NW Neighborhood Street Resurfacing Project DEO

CDBG Paving and Repaving Project

RFB 2019-01

AMENDMENT NUMBER 4

Driveway Detail For New and Existing Driveways

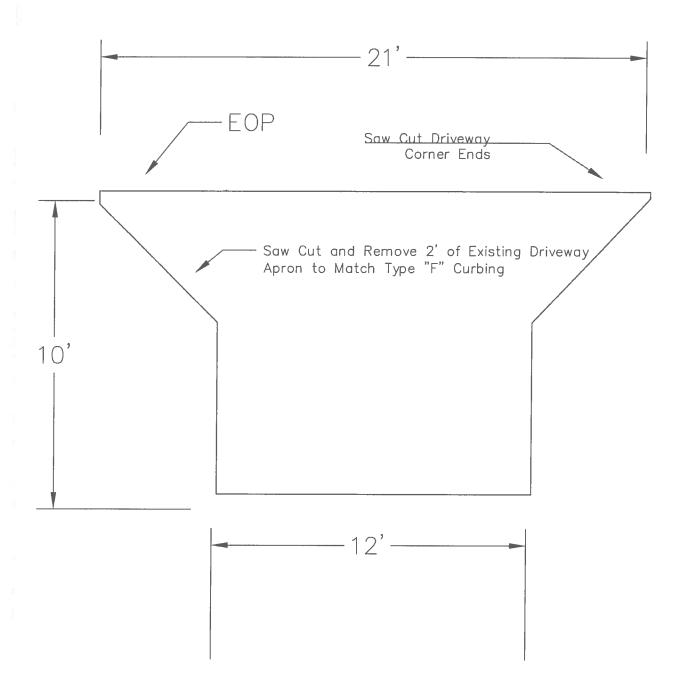
Answer: Reference Question 6, Answer.
- 11. Can the COA driveway details be provided?

<u>Answer</u>: Reference the driveway detail drawing and the Scope of Work Section 1.3 (F)
- 12. What will be required for the shoulders?
